ADDENDUM TWO

West Campus Maintenance Building Addition - 2026
2101 E. Coliseum Blvd
Fort Wayne, IN 46805

Commission No.: F25111

Addendum Date: 9 April 2026

1 Electrical Power Plan - First Floor

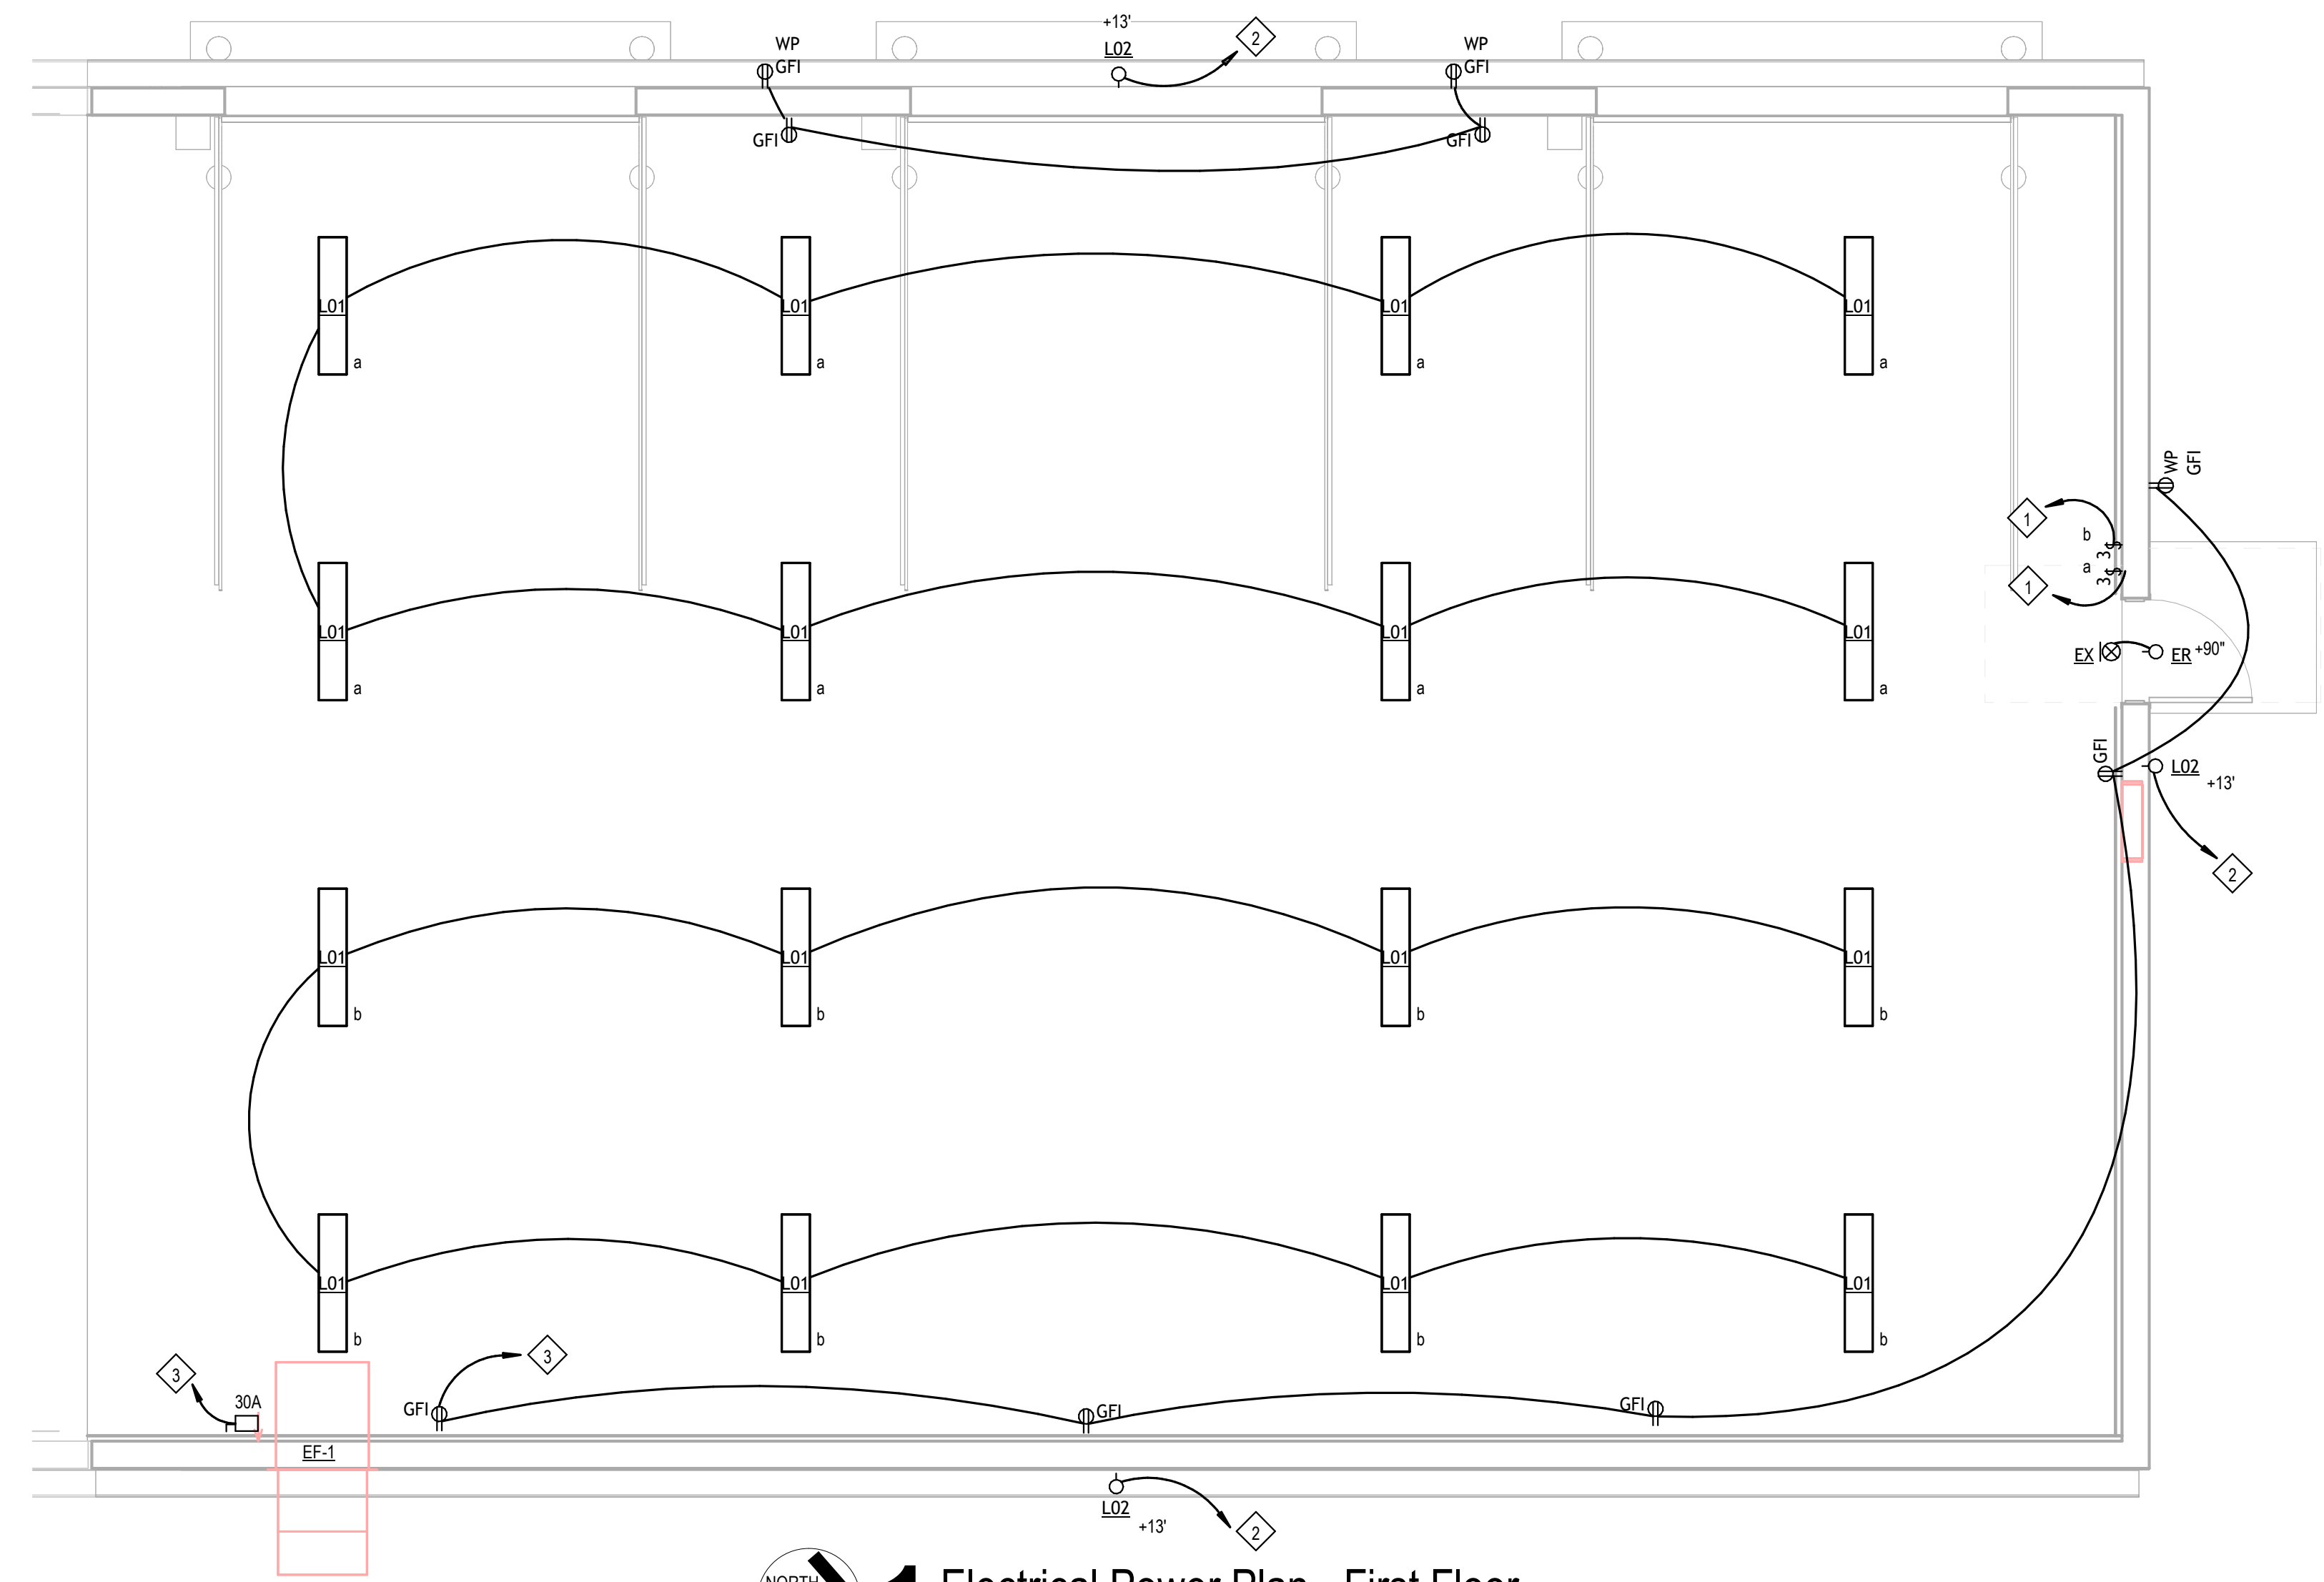
The print shows 2- new 3 way switches on addition. Are they wanting the new lights to be connected to the old lights and 3 way for both sides?

Per note 1 on E101, extend the existing circuit. Clarification added to drawing.
